Hybrids III Conforming Manual Revisions

Markets & Reliability Committee
June 18, 2025

FERC Docket [ER25-1095](#):

Resource Type	eDART Reportable MW
For the inverter-based component of Hybrid Resource	Based on nameplate MW rating of the component
For the non-inverter-based component of Hybrid Resource	Total RPM (Owned) iCAP (Committed + Available) MW

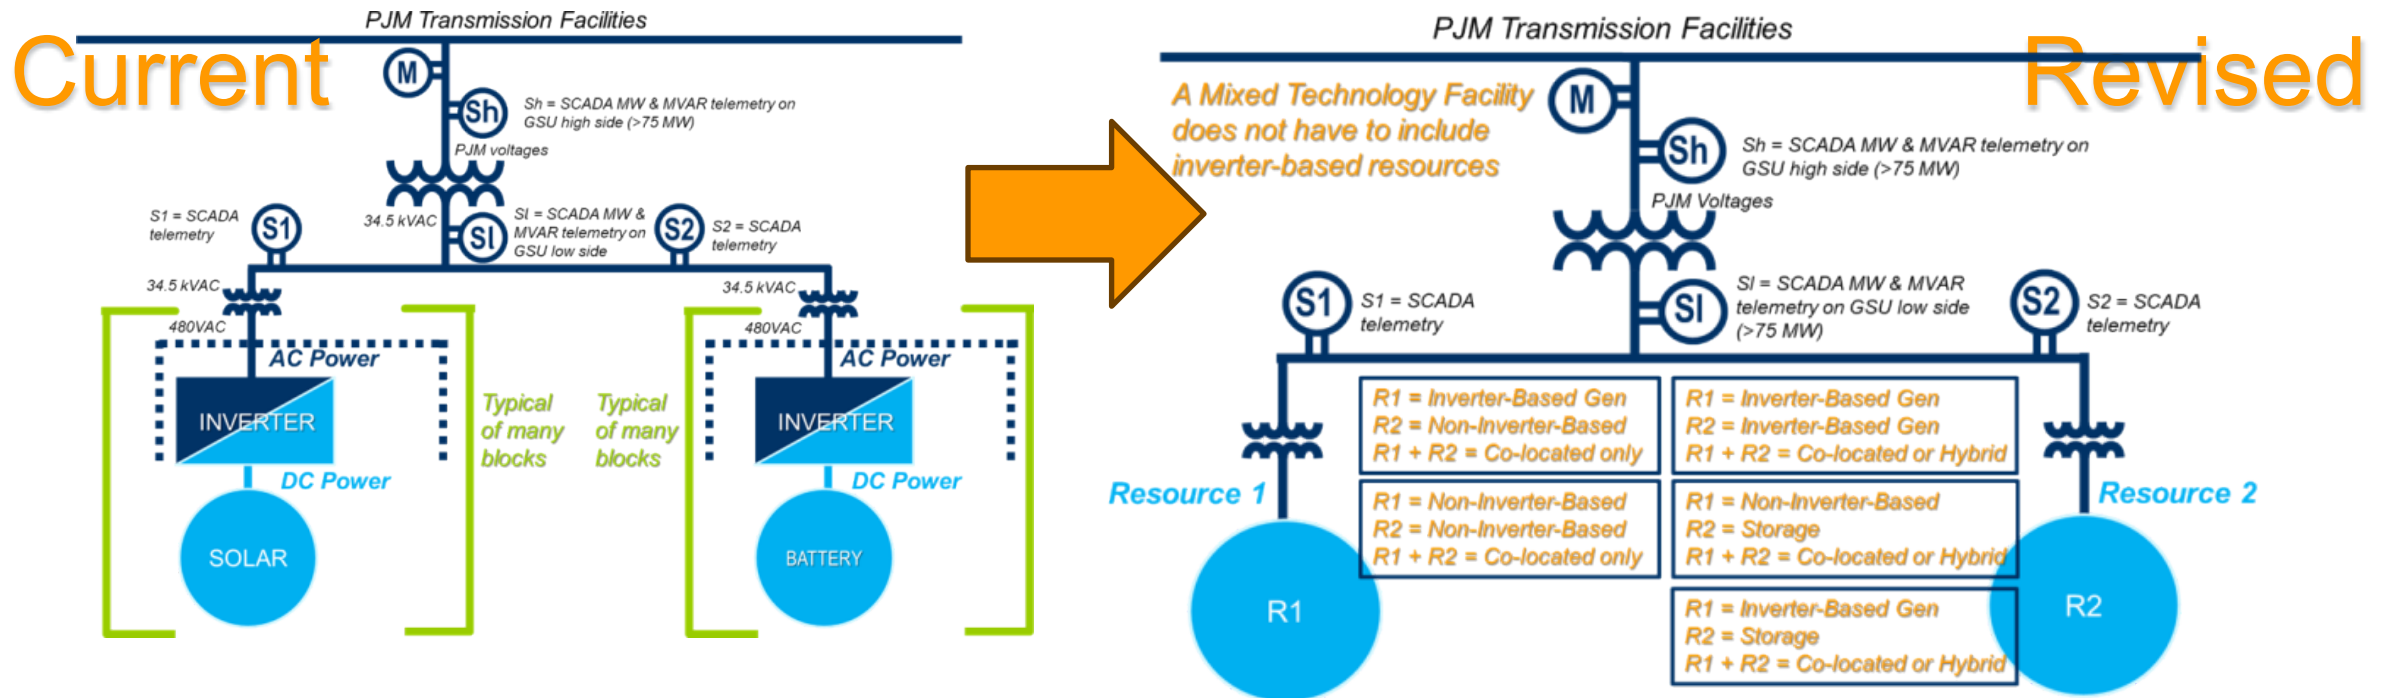
- Section 2.1 Generation Outage Reporting Overview
 - Updated eDART Reportable MW table (Exhibit 3) to include the reportable MW value of non-inverter-based components of Hybrid Resources

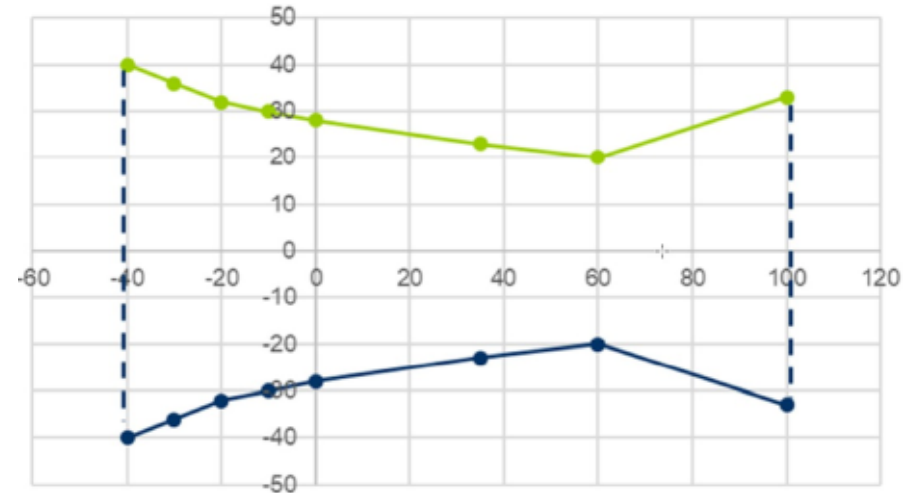
- Section 13.1 Marketing and Classification of Mixed Technology Facilities
 - Modified language to broaden eligibility to participate as a Hybrid Resource
 - Clarified classifications of open-loop and closed-loop based on definition changes
 - Updated language and diagram to be inclusive of all eligible resource types for hybrids
 - Updated language to specify when a Mixed Technology Facility must participate as a Hybrid Resource
 - Noted classification of closed-loop for any Hybrid Resource without storage component
 - Clarified that for all Mixed Technology Facilities participation change notifications must be made no later than six (6) months in advance of its initial start in the energy markets.
